# Groundwater Transfer Review Summary Form

Transfer/PA # T- 14523

Application: T-14523

Applicant Name: Sester Farms Inc.

**Hydrograph – area wells**

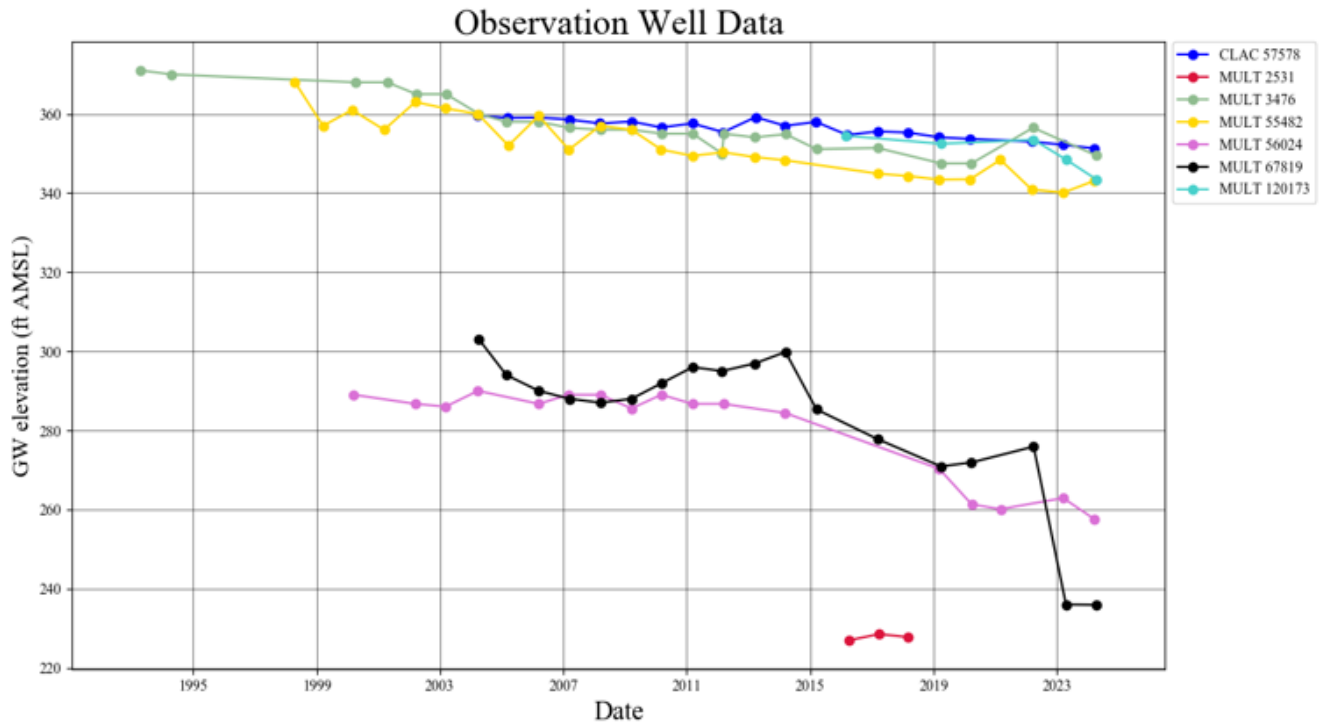
Head differences in area wells, including authorized POA wells MULT 3476 and MULT 67819, suggest that some of these wells *might* be completed in discretely-different alluvial aquifers (see attached hydrograph). In much of the Portland Basin the USGS has identified several alluvial aquifer systems: the uppermost "Troutdale Gravel Aquifer" (TGA), the intermediate "Troutdale Sandstone Aquifer" (TSA), and the deepest "Sand and Gravel Aquifer" (SGA). In most areas Confining Unit 1 (CU1) separates the TGA from the TSA, and Confining Unit 2 (CU2) separates the TSA from the SGA; these separations are most pronounced in more central portions of the Portland Basin nearer to the Columbia River, but are also generally present in the POA/POU area. Underlying these alluvial deposits is bedrock comprised of basalt of the Columbia River Basalt Group (CRBG) (Swanson and others, 1993; McFarland and Morgan, 1996).

**Hydrograph – Authorized POA MULT 3476 (“Well 1”)**

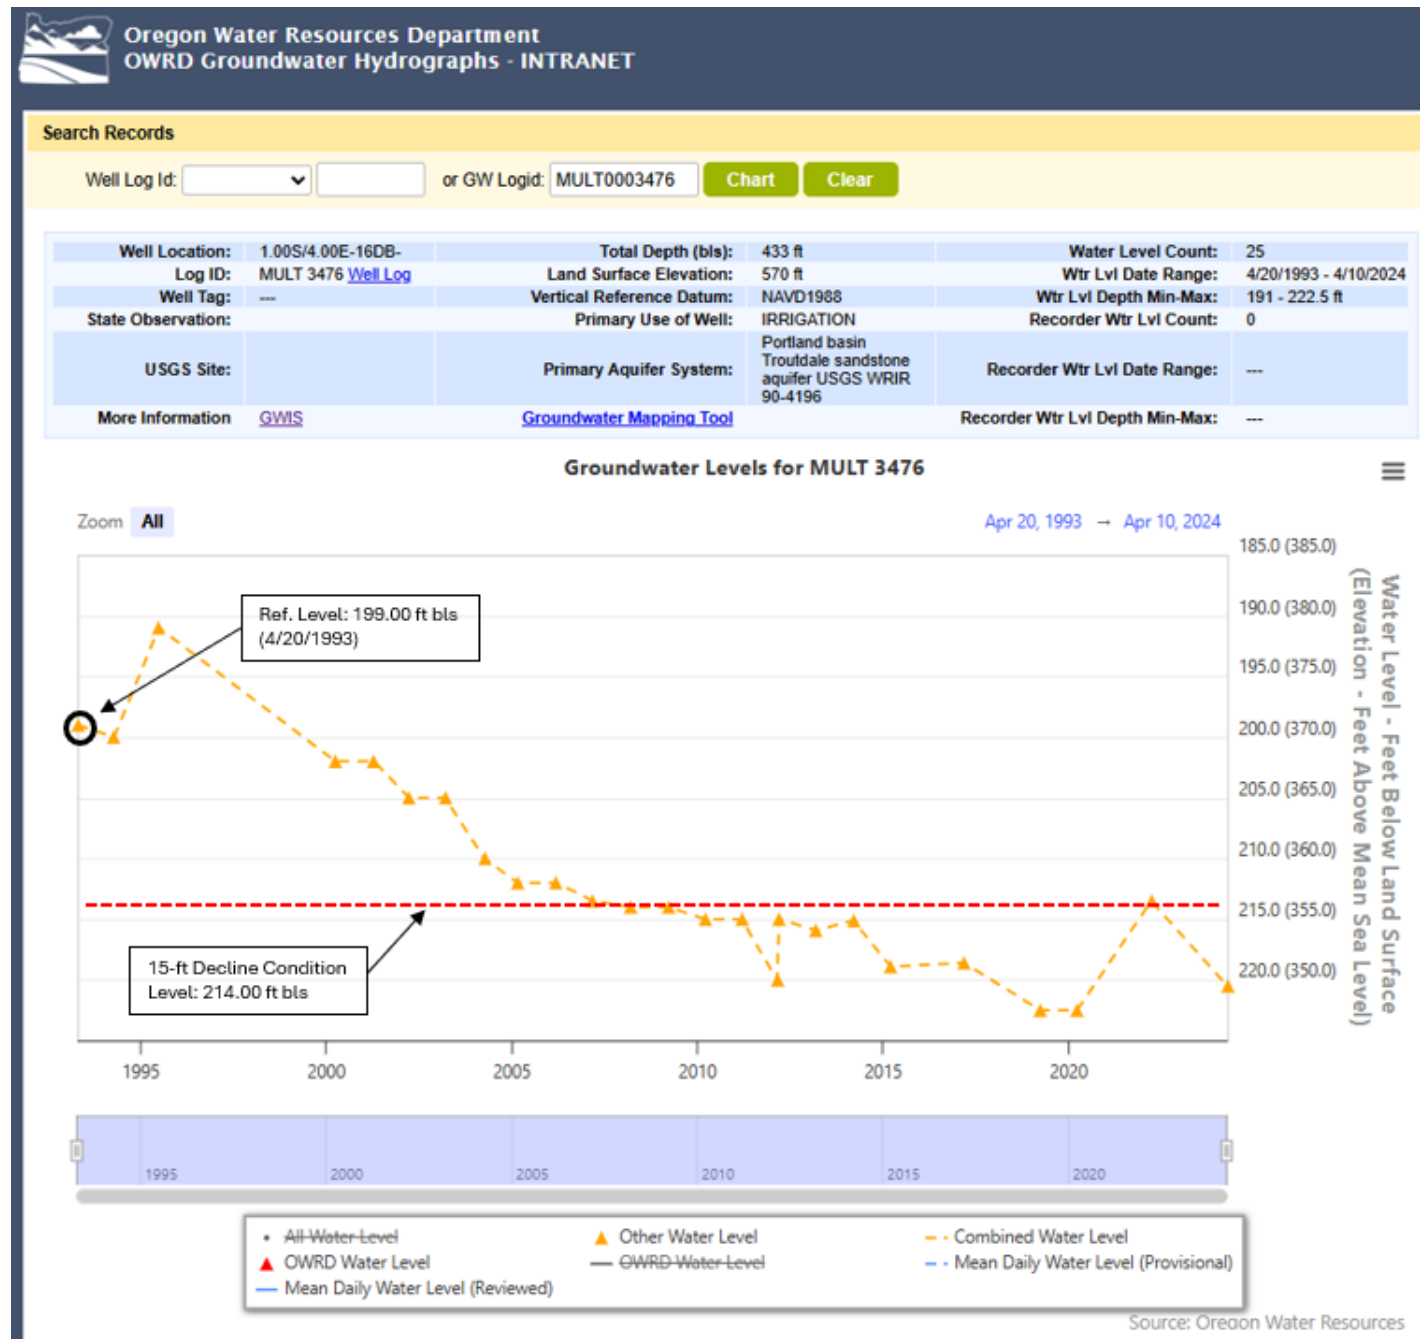
Note: reference levels for authorized POA MULT 3476 and MULT 67819 were established in the extension review for permit G-15196 completed by OWRD on February 7, 2024. Also, see attached hydrographs for both MULT 3476 and MULT 67819.

- MULT 3476 reference level: 199.00 ft bls (thus 15-ft decline trigger level = 214.00 ft bls)
- **MULT 3476 4/10/2024 level: 220.5 ft bls = > 15-ft decline condition exceeded**
- MULT 67819 reference level: 317.00.00 ft bls (thus 15-ft decline trigger level = 332.00 ft bls)
- **MULT 67819 4/10/2024 level: 384.10 ft bls = > 15-ft decline condition exceeded**

**Cross-section, relevant wells/POA locations (oriented roughly north-south)****Theis Drawdown Analysis – Authorized POA “Well 2” (TBD) to MULT 139288****Theis Time-Drawdown Worksheet** v.3.00

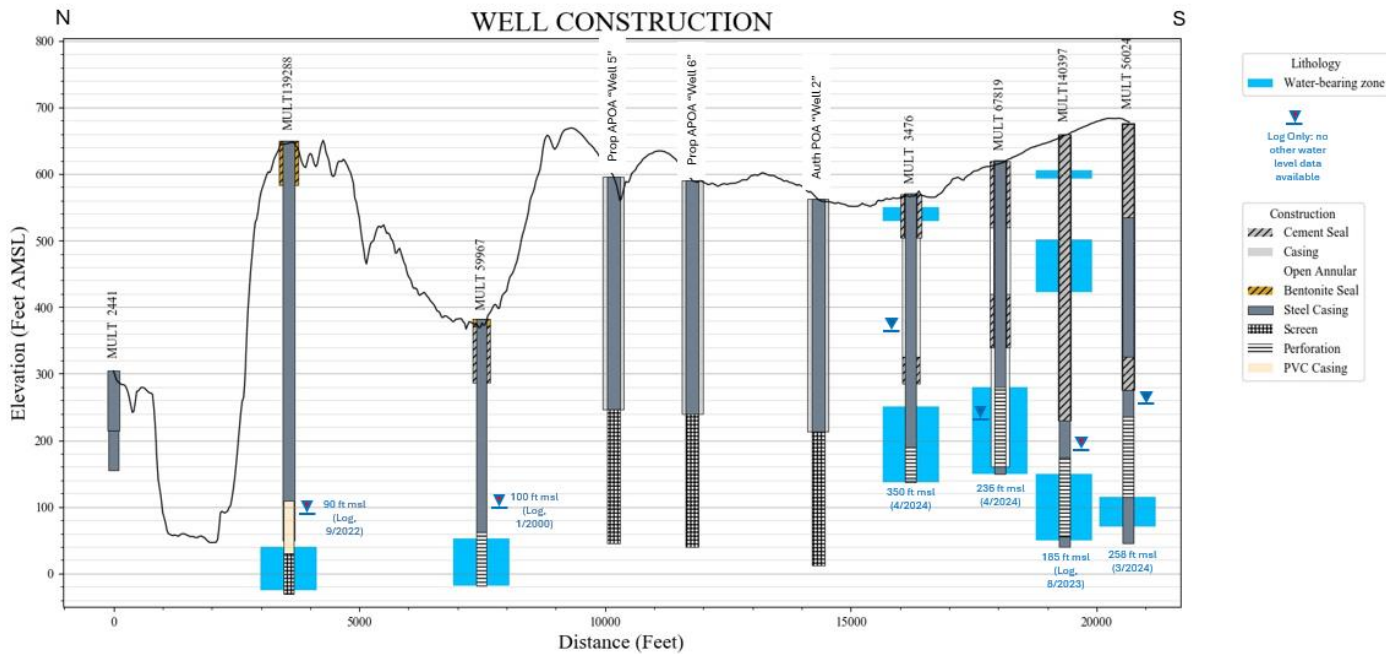
Comments: The nearest known groundwater right potentially affected by the proposed use is MULT 139288, a domestic use well located north of the proposed “Well 6” location. Relative to the authorized POA “Well 2” location (TBD), the proposed APOA “Well 6” location is approximately 2400 feet nearer to MULT 139288; consequently, the proposed use is likely to result in an increase in interference in MULT 139288 (see attached cross-section).
